Project Number 001-2017  
April 19, 2019

Contract Documents  
Masjid Sunnah Renovation  
2312 South Division Avenue  
Grand Rapids, MI 49507

Addenda No. 3A

**A101**

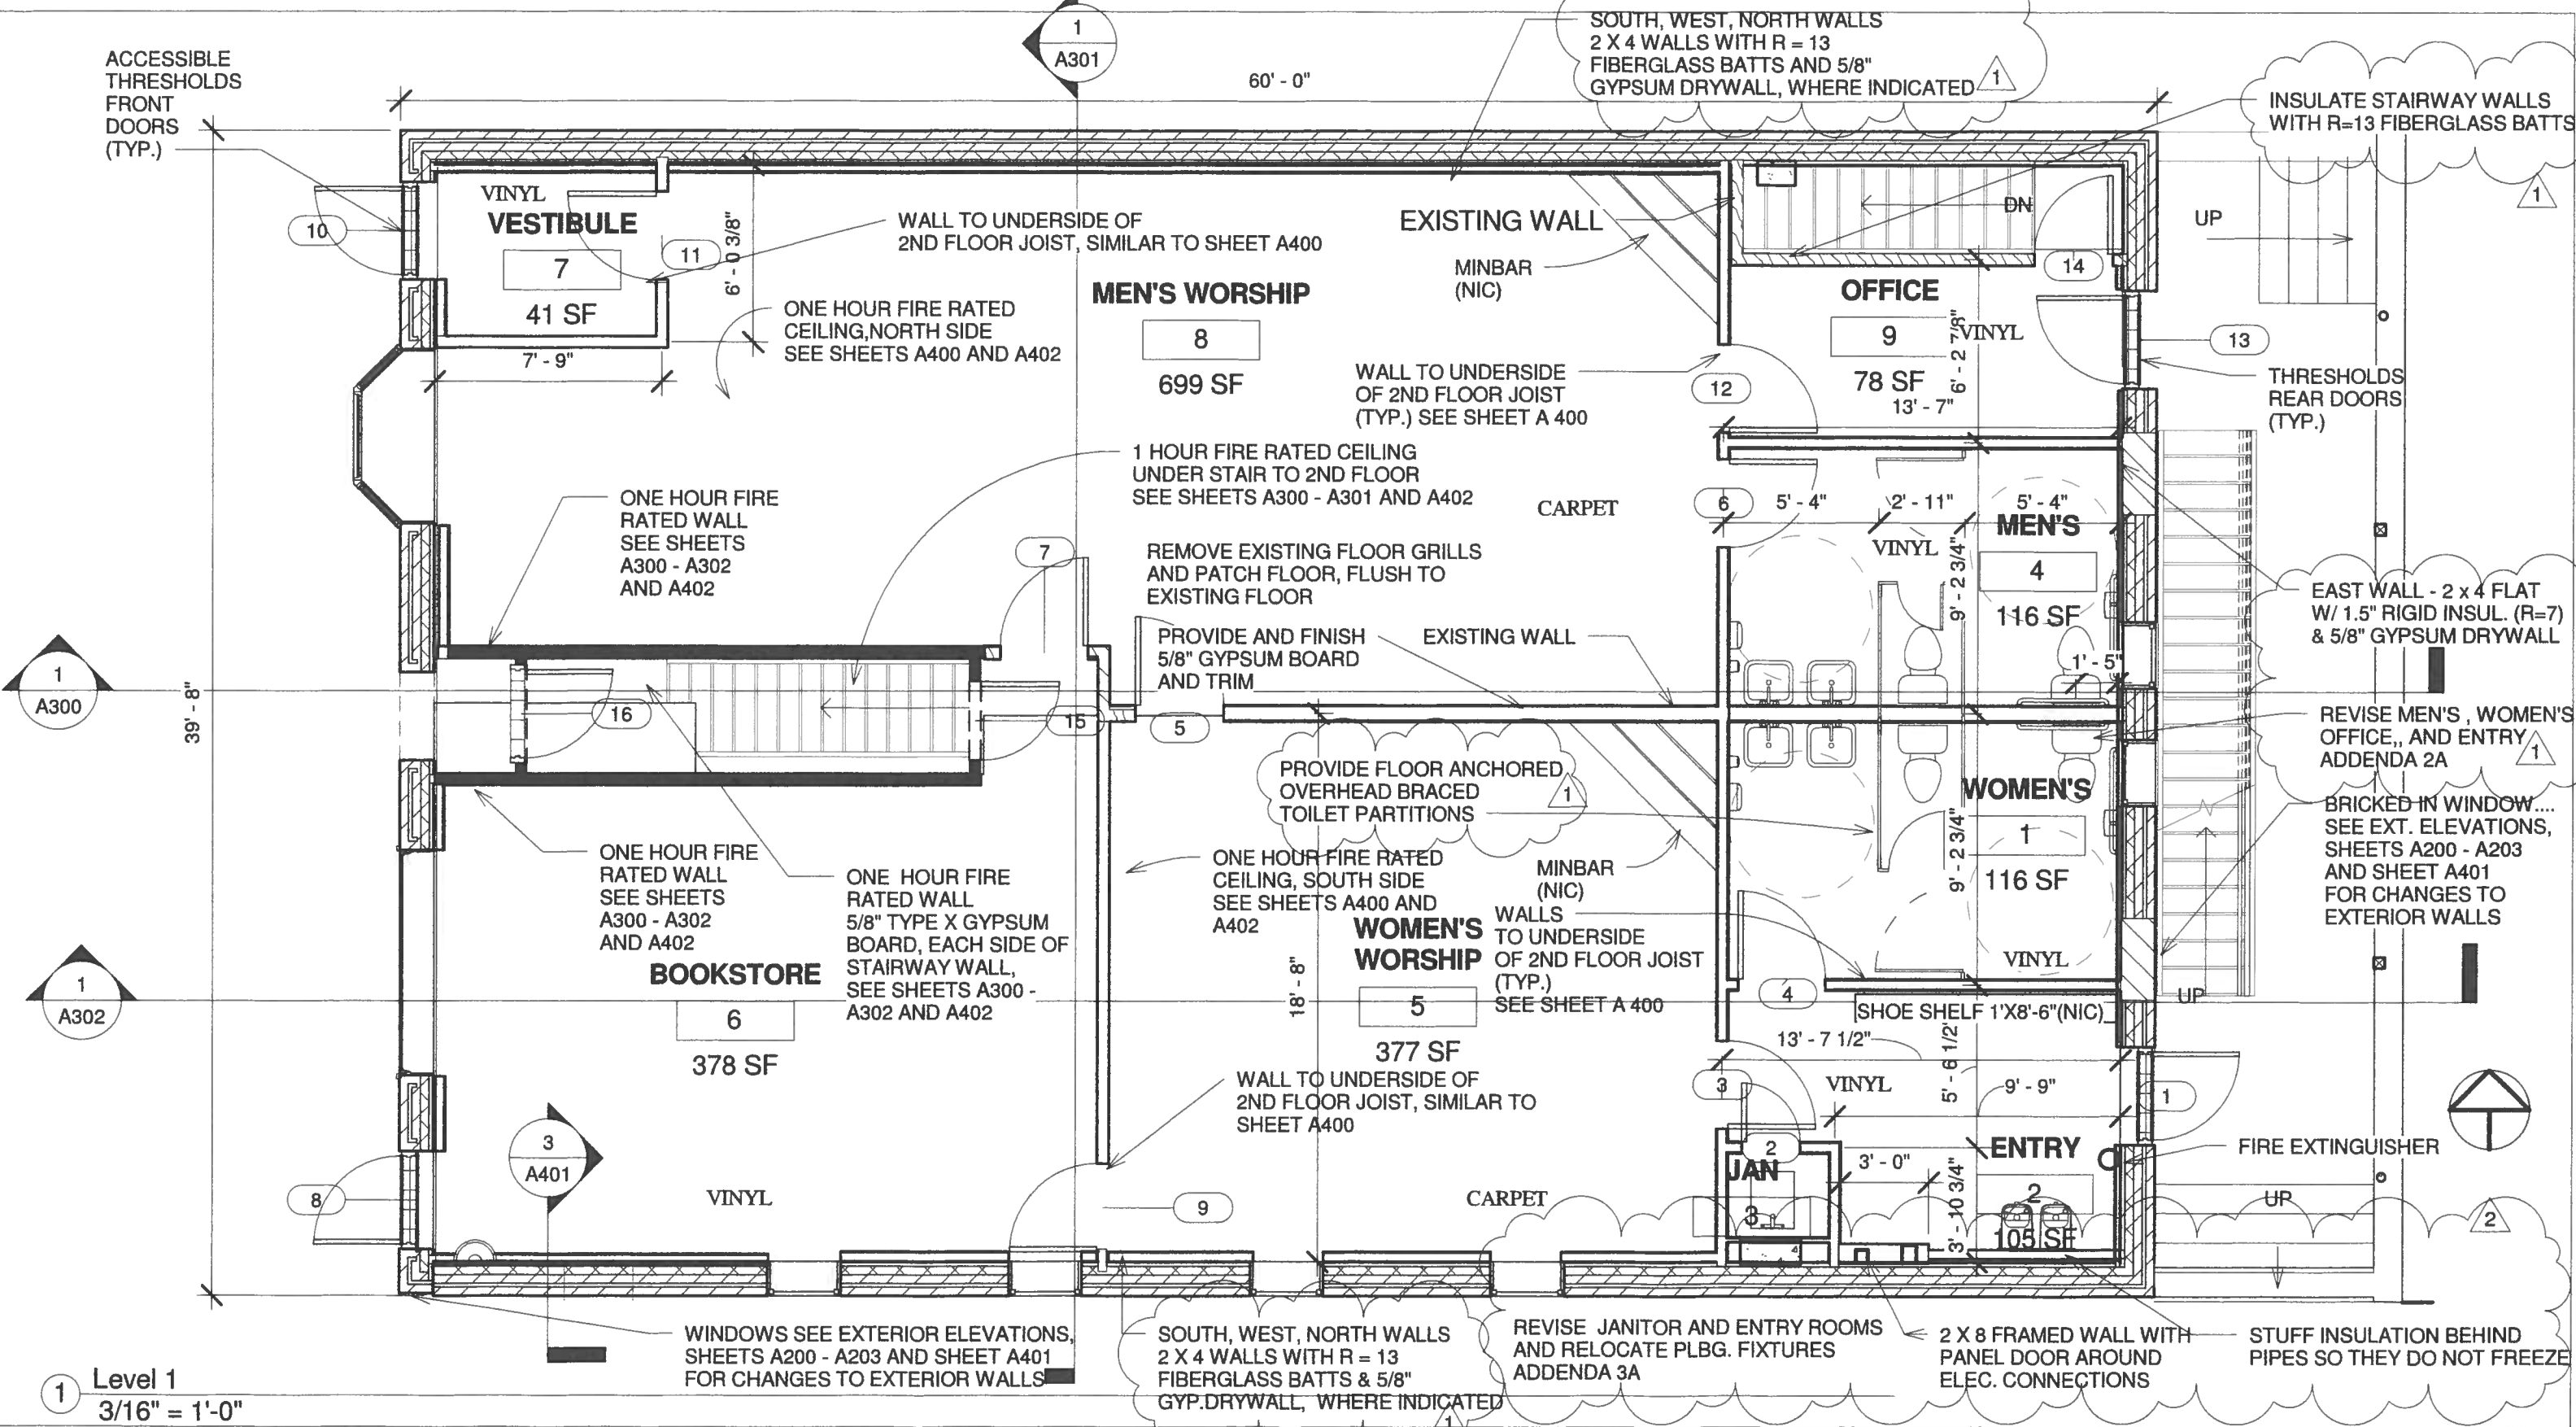
Sheets A101, Revision to Janitor and Entry Area, See attached plan
